Re: Toat Café, Stanes Cottage, Stanes Farm & Whitelands Farm, Pulborough RH20 1DN

Planning Ref: DC/26/0826

Consultee Letter from LLFA dated 20/07/26

Figure 1: Surface Water flood risk

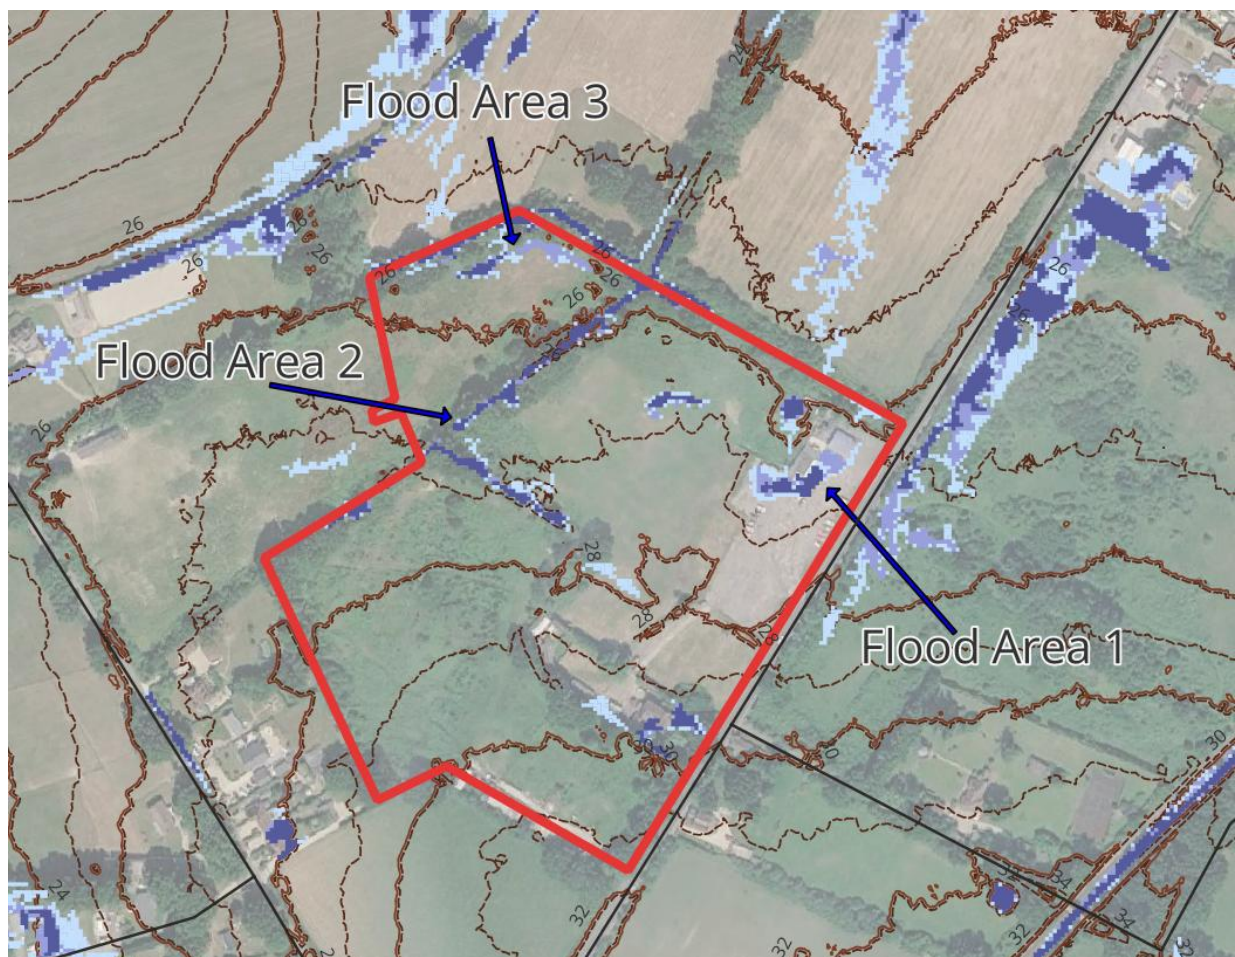
A more detailed plan of the existing surface water flooding extents is provided in Figure 1 below. The LLFA noted their concern over the flooding predicted at Flood Area 1 in the north-east corner of the site.

This area of flooding is a discrete flood area which is predicted to pond to the extents shown. There is no overland flow through this area, and therefore this area of flooding is not caused by flows from outside the site, nor does it exit from the site. It is considered to be caused by runoff solely from the

4,000sqm car park which has an impermeable surface formed from compacted hardcore material (see Figure 2 below) and does not have a designed drainage system. Since the existing surfacing and the buildings on the site will be removed by the development and replaced with permeable surfaces with a defined drainage system, the presence of Flood Area 1 will not be present following completion, therefore will have no impact on the proposed layout.

Figure 3 – Connectivity to the river network using LiDAR and OS data

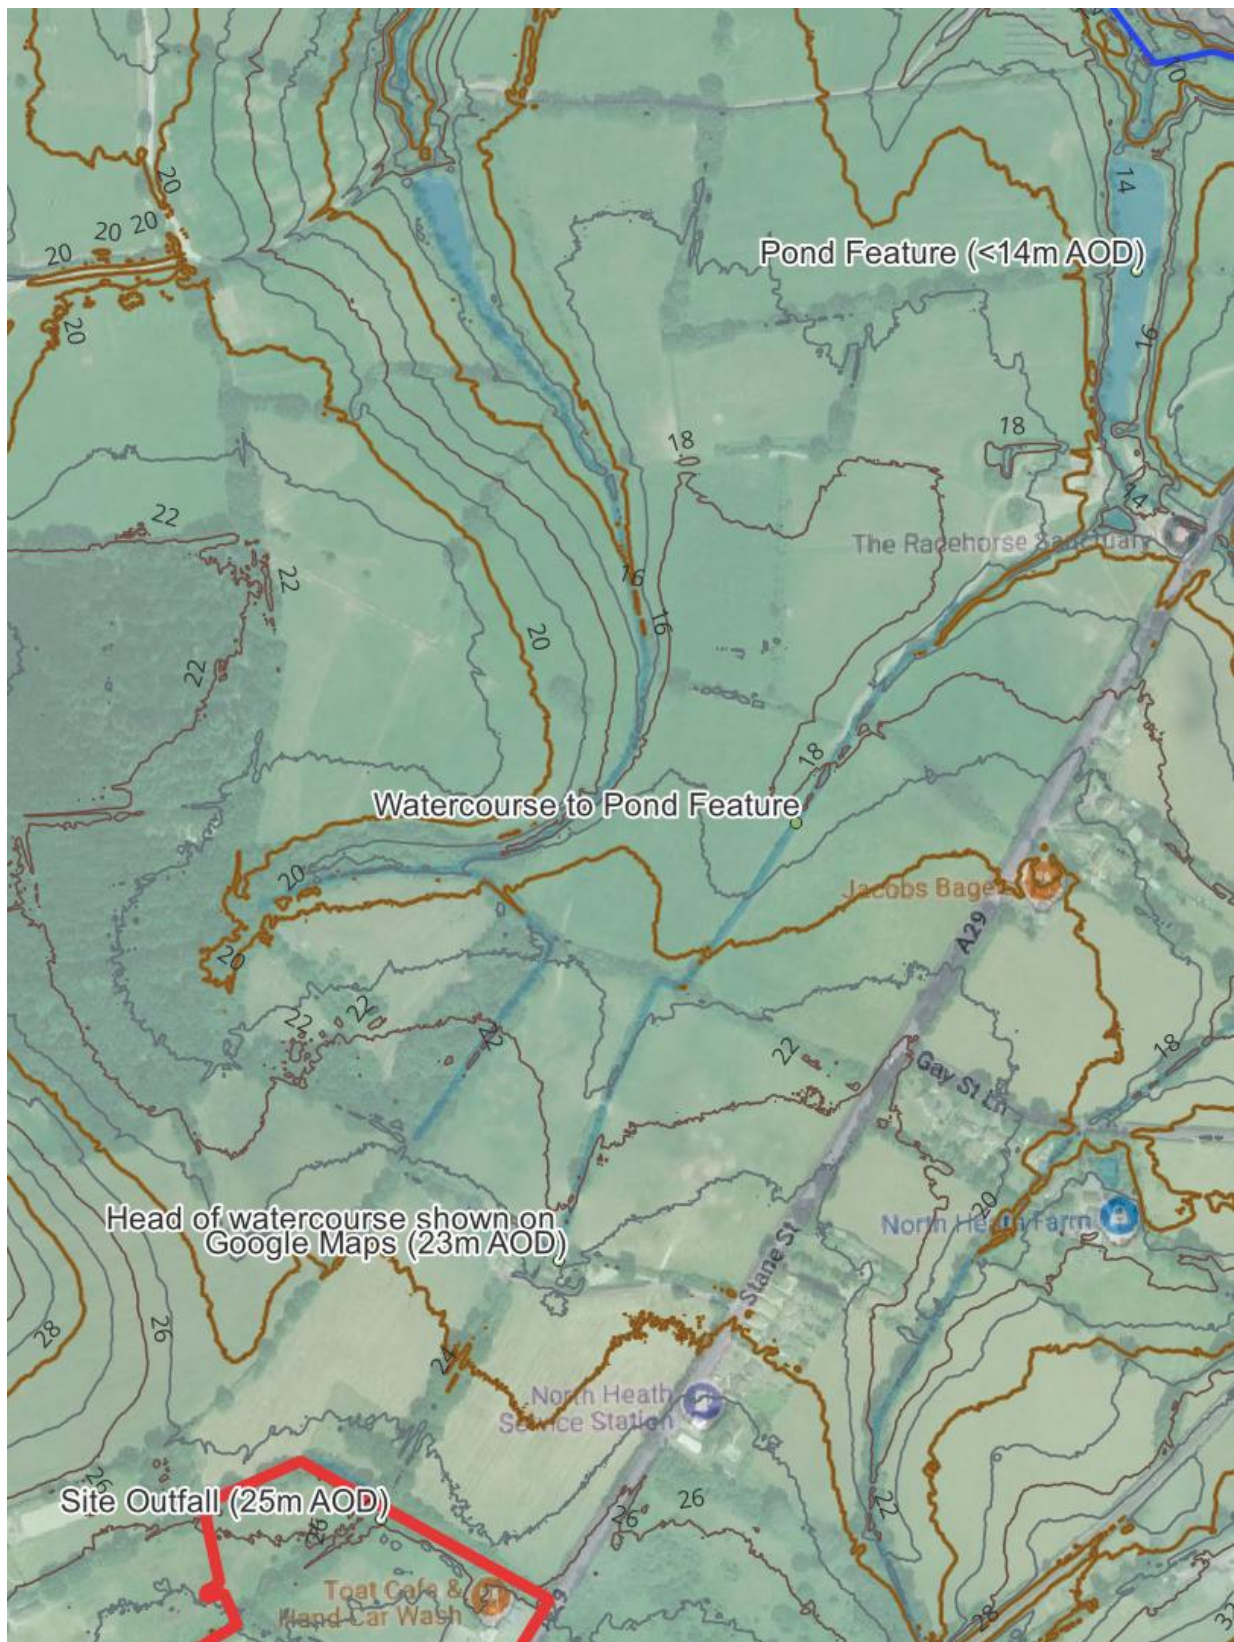
2. Connectivity to the surrounding watercourse network

Figure 3 below is presented to demonstrate the connectivity of the existing site to the river network. The data uses LiDAR data to show the contours and the OS Open Rivers shapefile to identify the river to the north-of the site. Google Maps indicates a watercourse to the north of the site at a lower elevation to the site outfall and the LiDAR contours support the fact that ditches are present to drain the adjacent fields.

The above is sufficient at Outline Application stage to establish the route connecting the site to the river network and, if required, more detail can be provided as part of a Reserved Matters application. There is no reason to suggest that runoff from the site does not already follow a route following field boundary ditches to the river network and there is no indication that flooding occurs currently. The development will limit the site discharge to the 50% Annual Exceedance Probability (i.e. that which occurs during a 1 in 2 year event).

Inspection of the site plan provides no indication that a 3m easement buffer to an existing watercourse cannot be provided and more detail can be provided as part of a Reserved Matters application.
